Agency Comment
Letters and Responses
on the Draft EIS/EIR
for the
Van Ness Avenue
Bus Rapid Transit Project

Agency Comment Letters and Responses

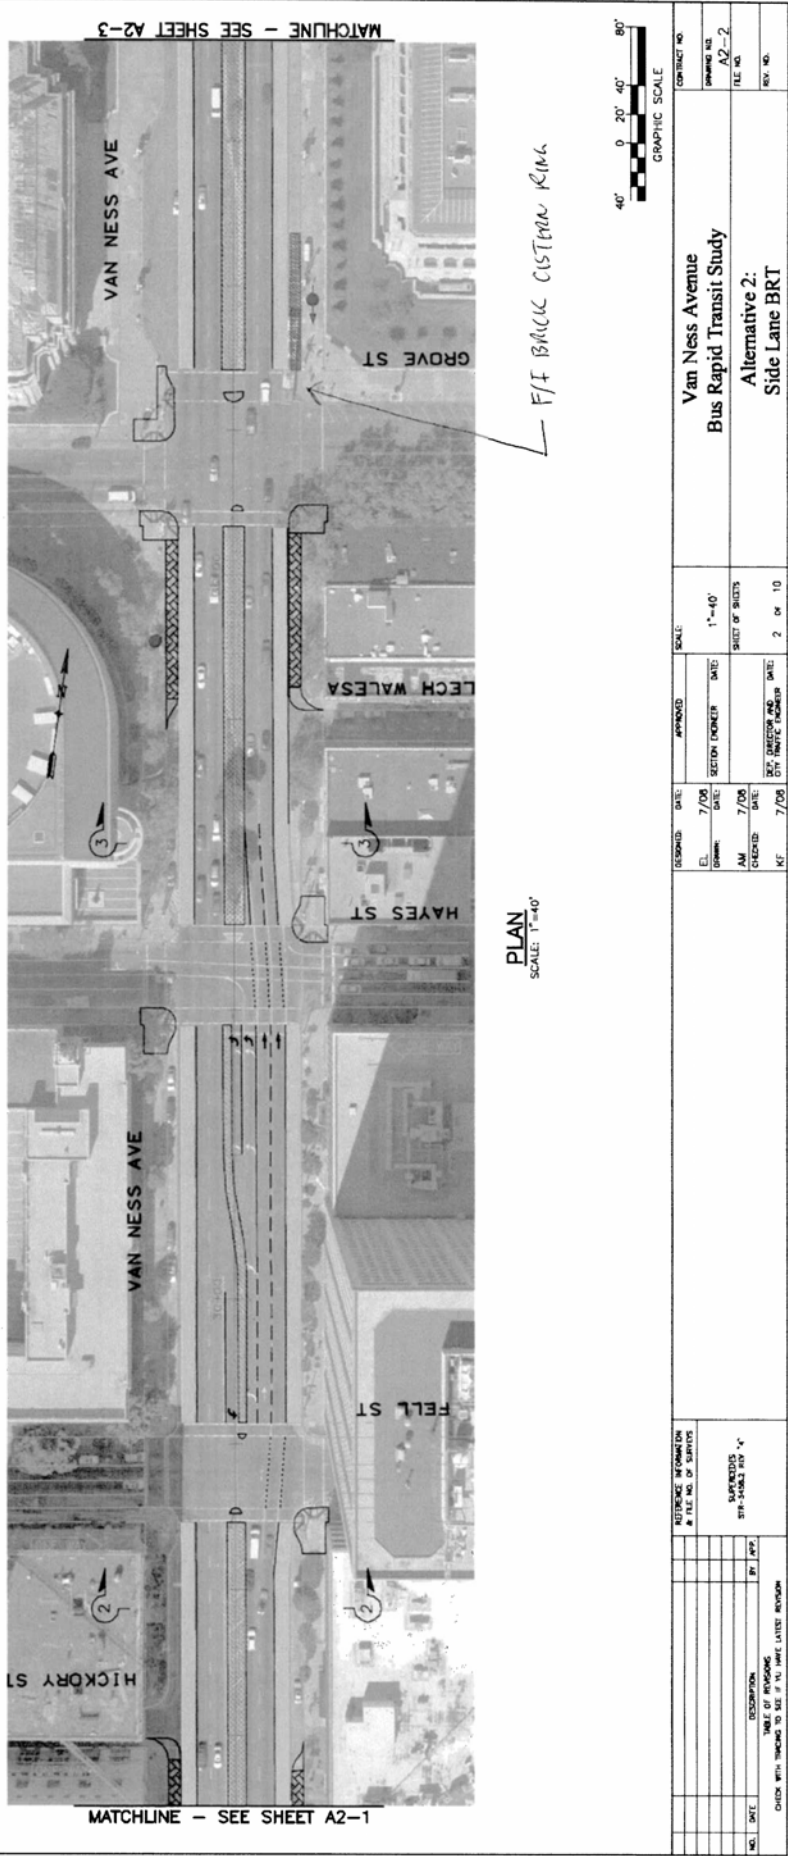
HP HYDRANT IN LANDSCAPED AREA WOULD REQUIRE 10'x10' CONCRETE PAD

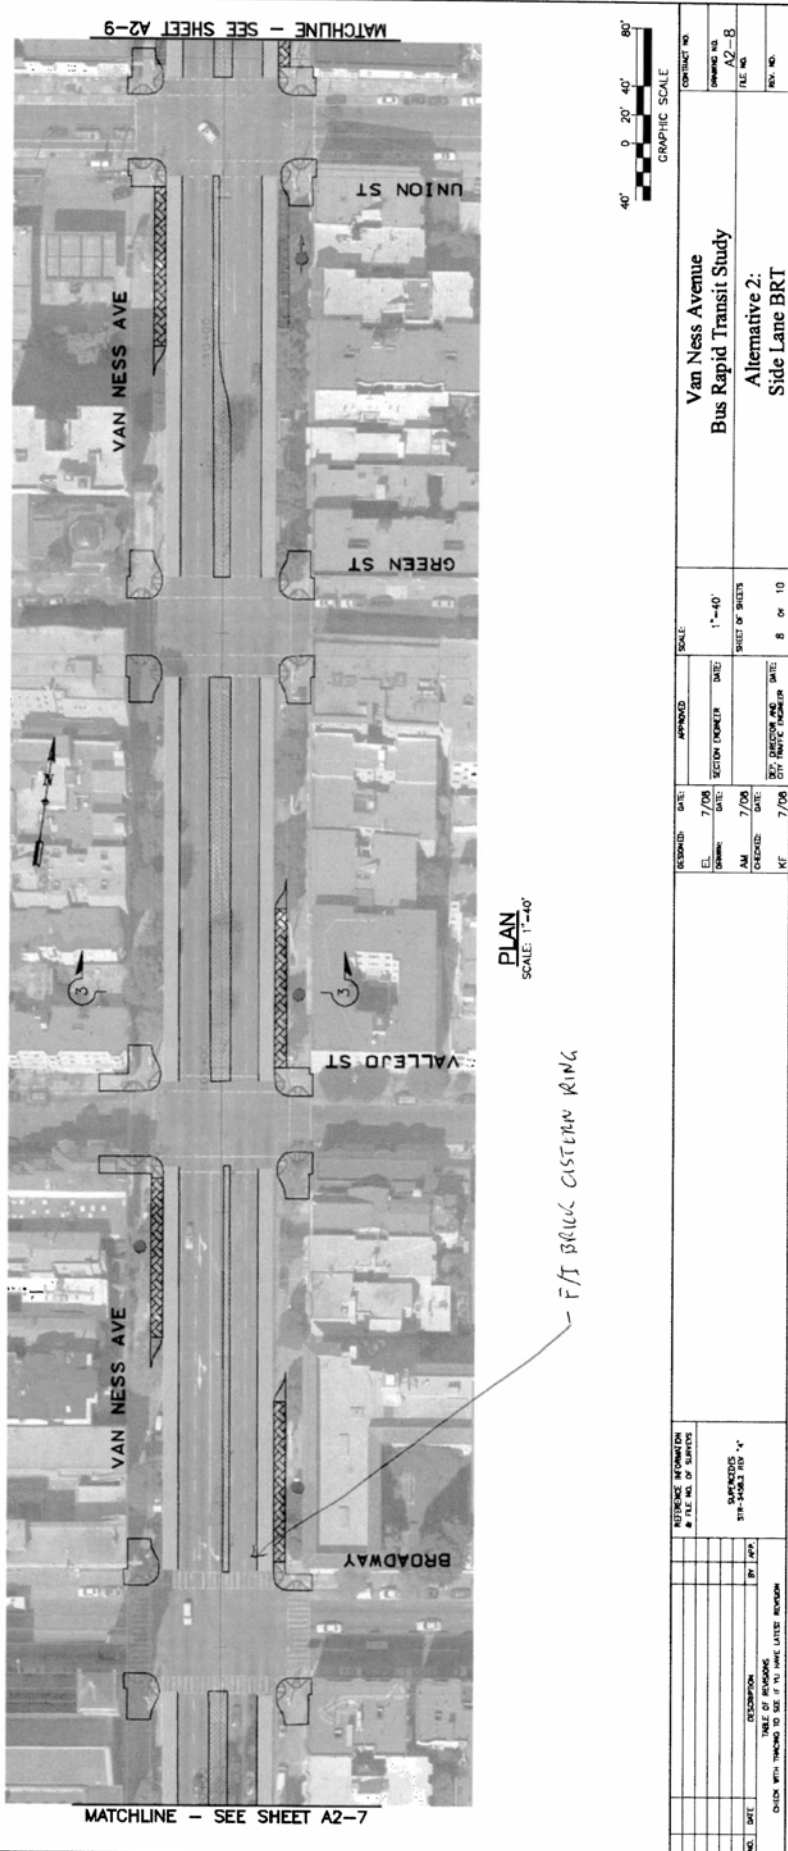
HP HYDRANT TO BE
RELOCATED TO 27"
FROM NEW CONC

F/I BLACK CISTERNA RING

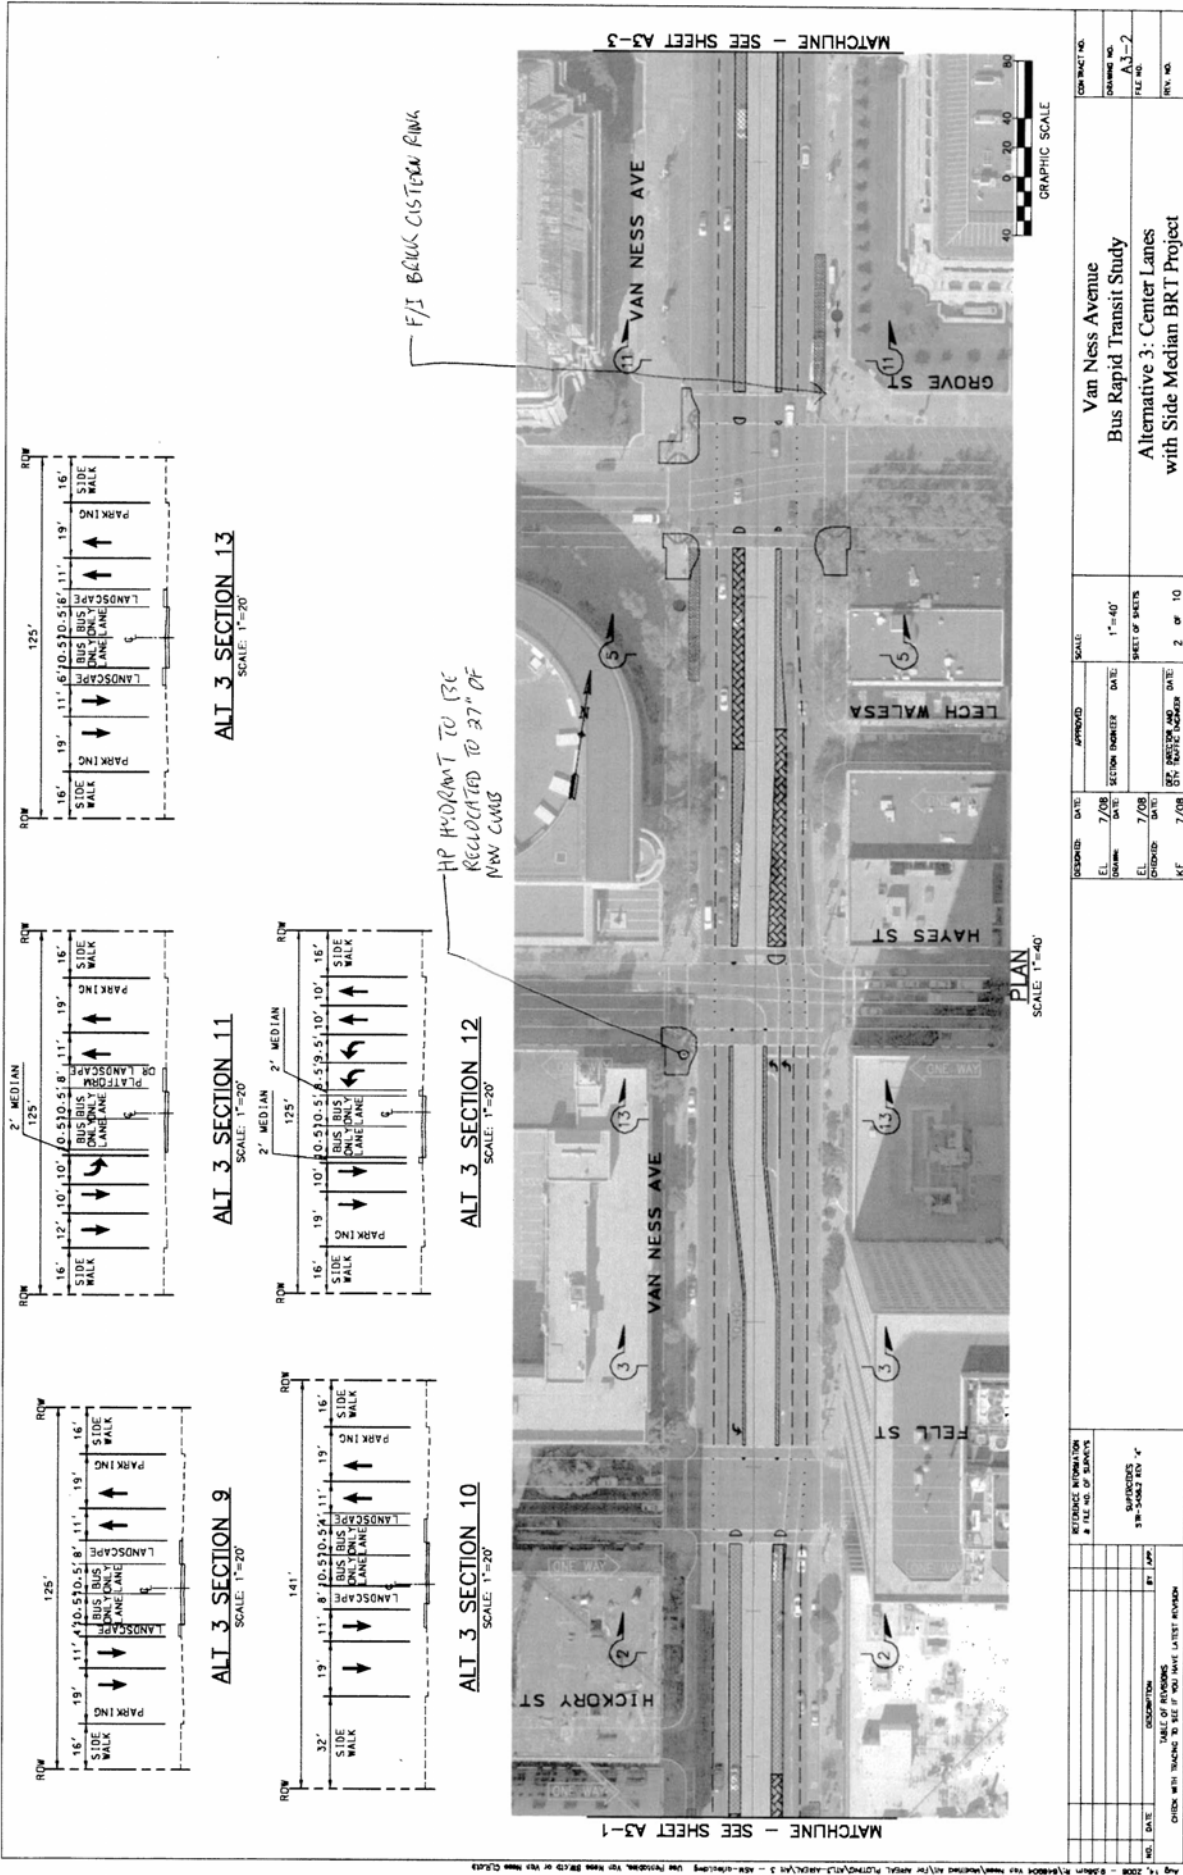
F/I BRICK CISTERN COVERS
RAISE CISTERN COVERS

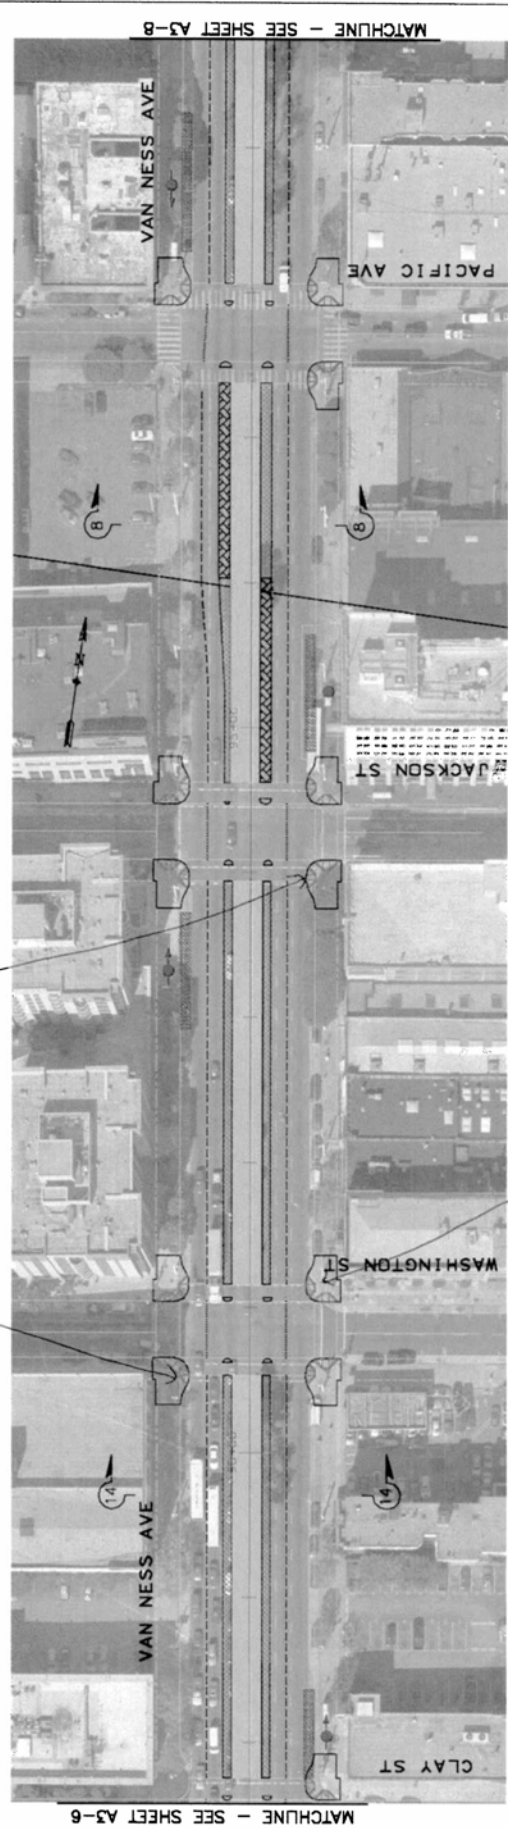
F/I BRACCE SYSTEM PLAN

HP HYDRA-MT TO BE
RELOCATED TO 37' FROM
NEW CURBS

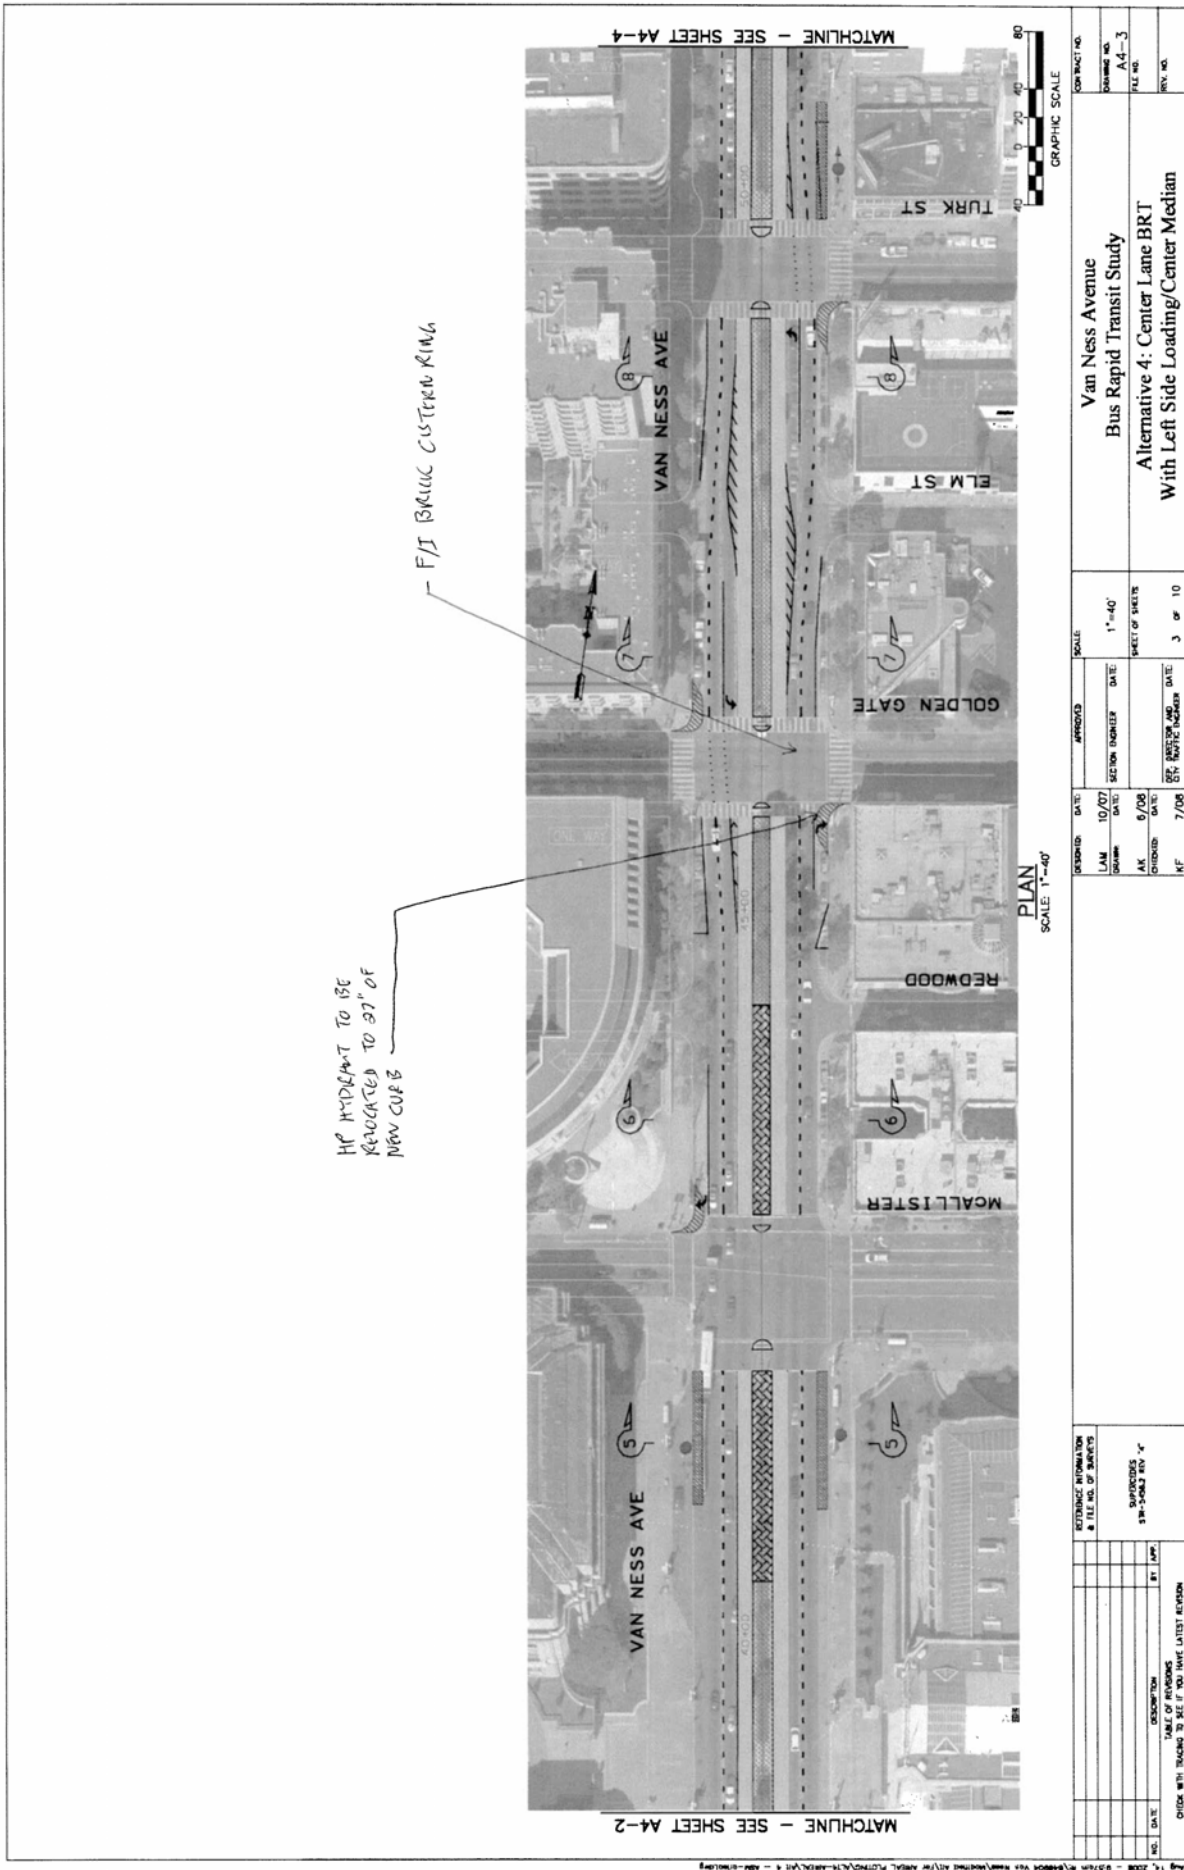
F/S BRICK CISTERN RING

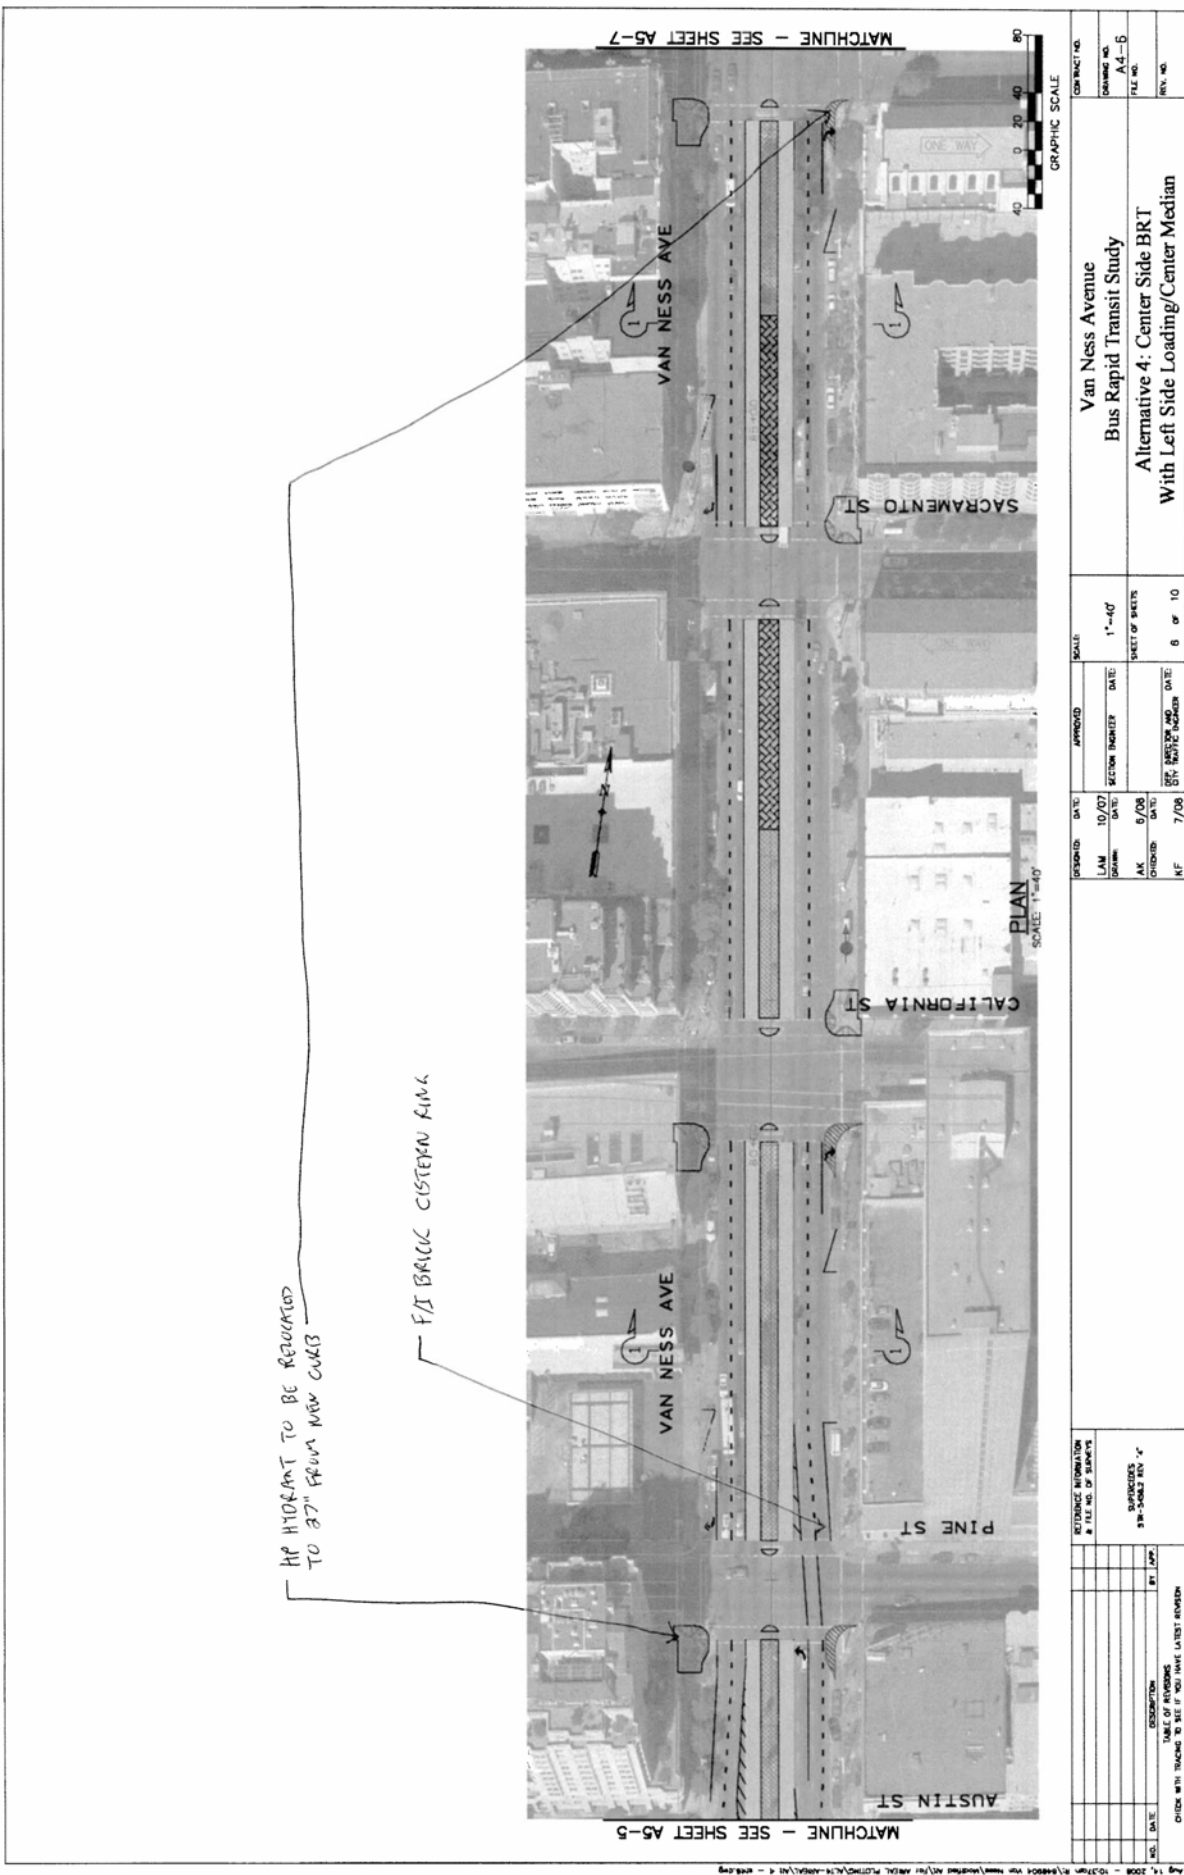
F/S BRICK SYSTEM RING

HP HYDRANT TO BE RELOCATED TO 37' FROM NEW CLUB
